Task Scope Review of Sandia WRC
Emergency Containment Vent
Design Package

To: Milt Levenson
Subject: Emergency Containment
Venting Package

Comments on emergency containment venting package received from Sandia/NRC follow:

RADIOLOGICAL CONSIDERATIONS

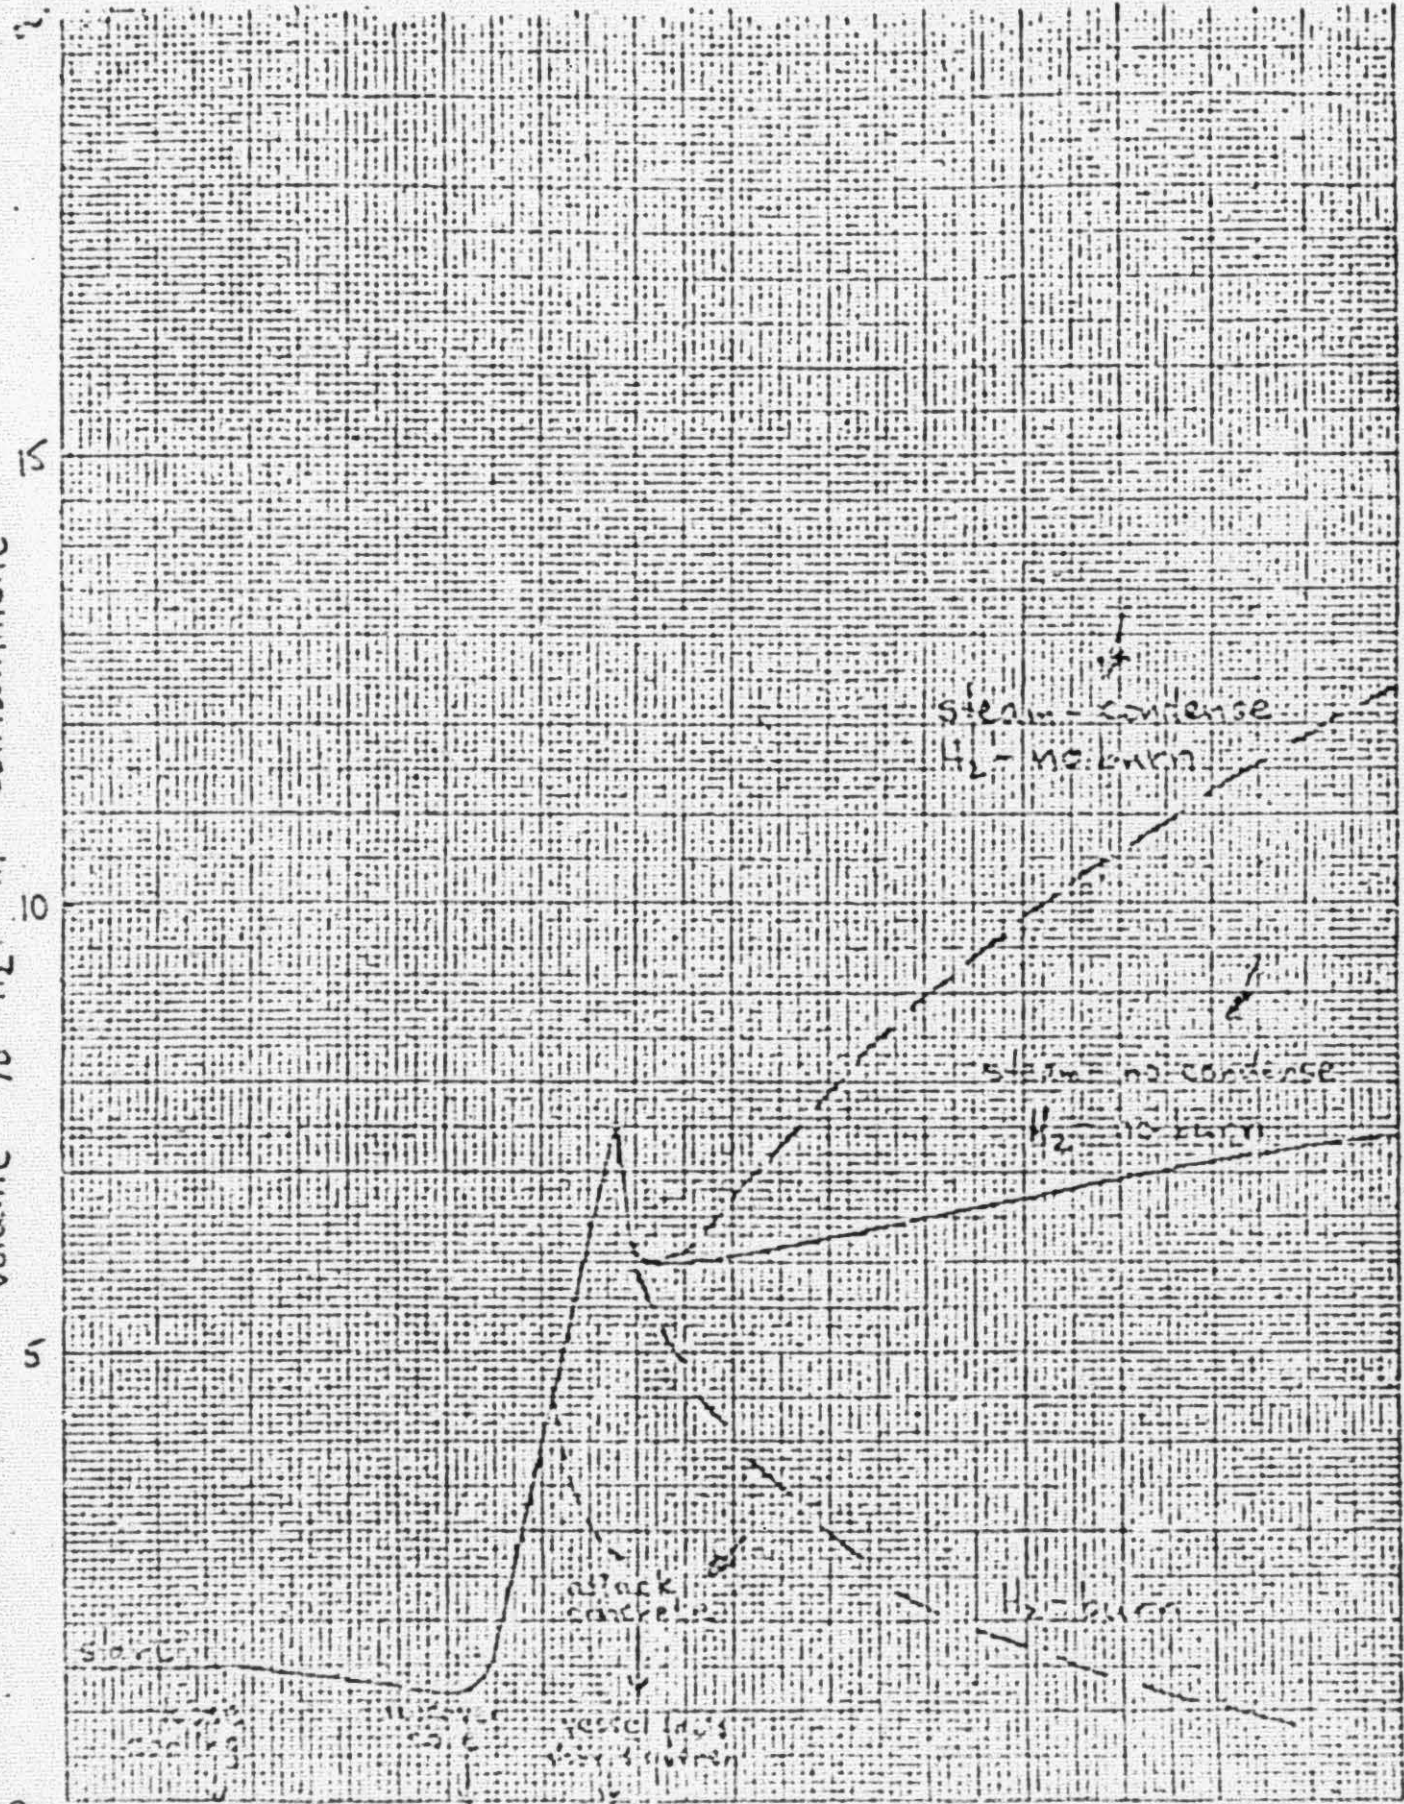
- (1) Page 1 - 10^6 Ci I release represents about 10% of current total activity of I-131 (core & RCS) seems reasonable - given core melt (no containment or vessel cooling) and containment failure above grade.

QUERIES AIRBORNE IN CONTAINMENT

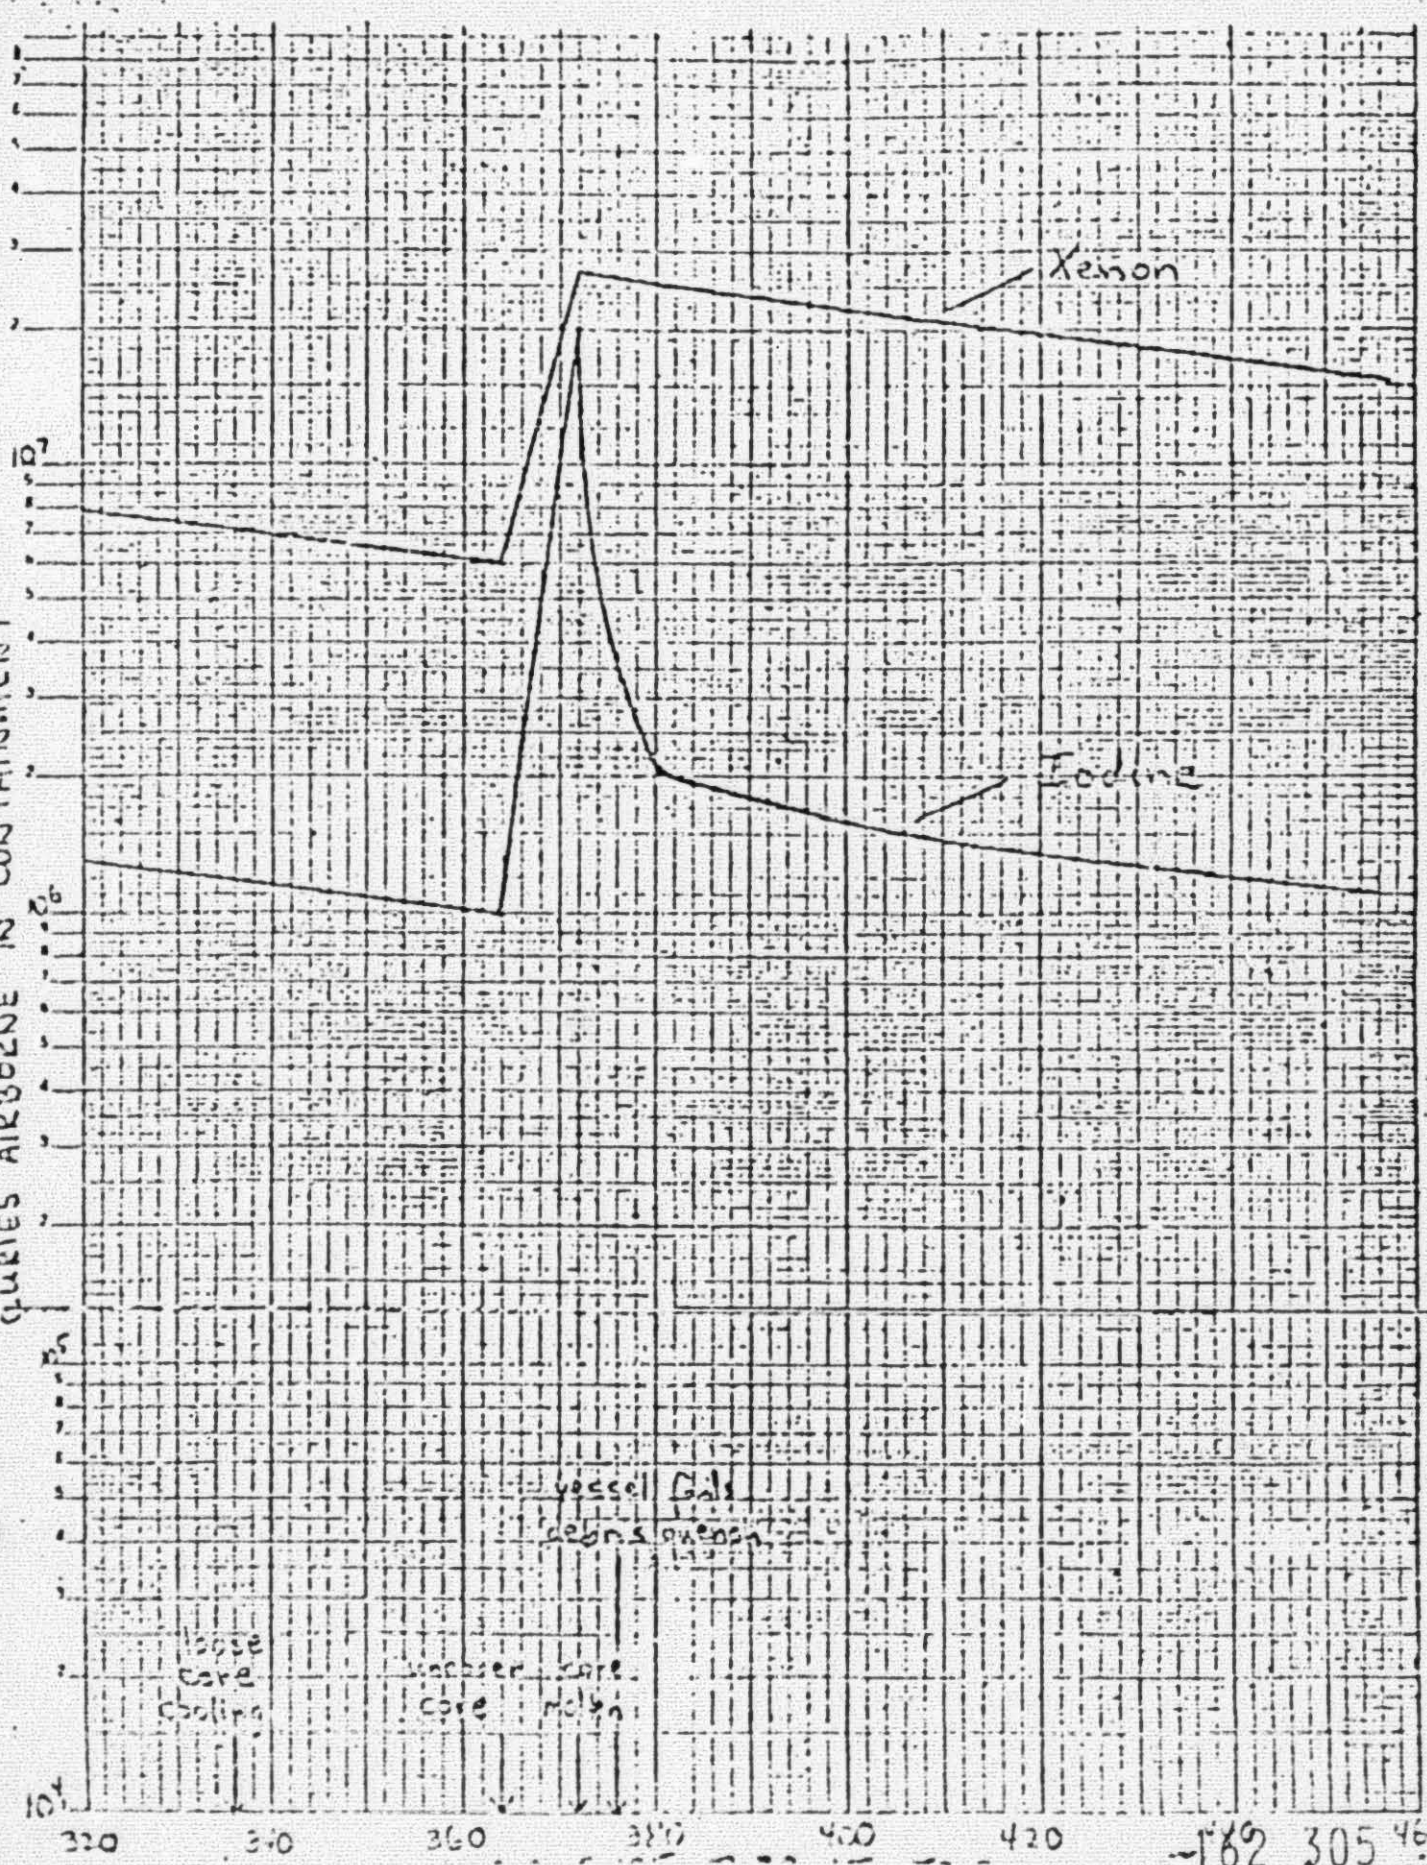
- (4) Page 4 - Appears to postulate 20% Core I-131 becomes airborne.
- (5) Page 5 - System Design
 1. All air handling systems should be designed for 150 psig if maximum utility is to be gained (150 is probable containment failure pressure).
